MECKLENBURG COUNTY HEALTH DEPARTMENT

APPLICATION FOR PERCOLATION TEST

5) SUBDIVISION FARMWOOD #8 LOT NO 21 BLOCK NO. J

SITE INVESTIGATION REPORT
INDIVIDUAL SEPTIC TANK SYSTEM
WITH SUBSURFACE,
SOIL ABSORPTION,
EFFLUENT DISCHARGE

APPENDIX H
SITE EVALUATION

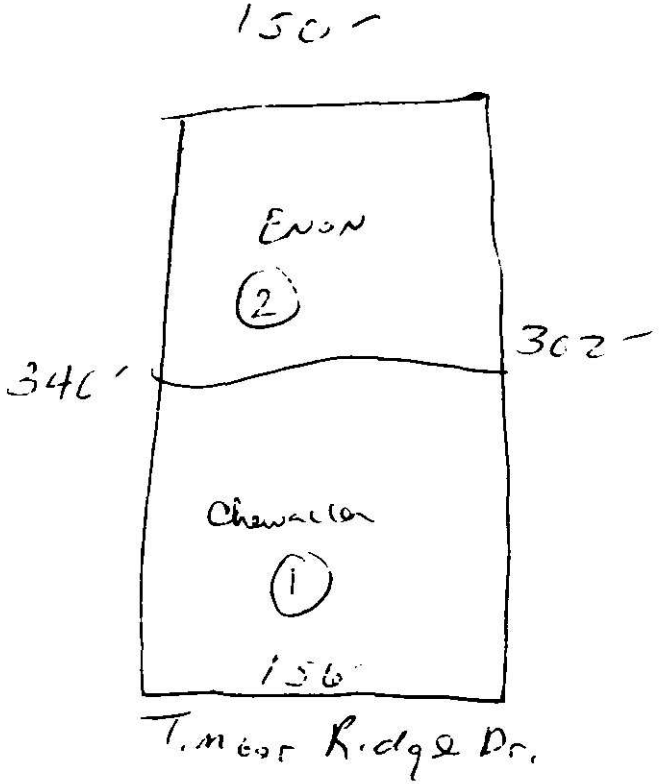
Additional Comments: Based on this investigation the lot would have soils demonstrating high water table for installation of a septic tank system.
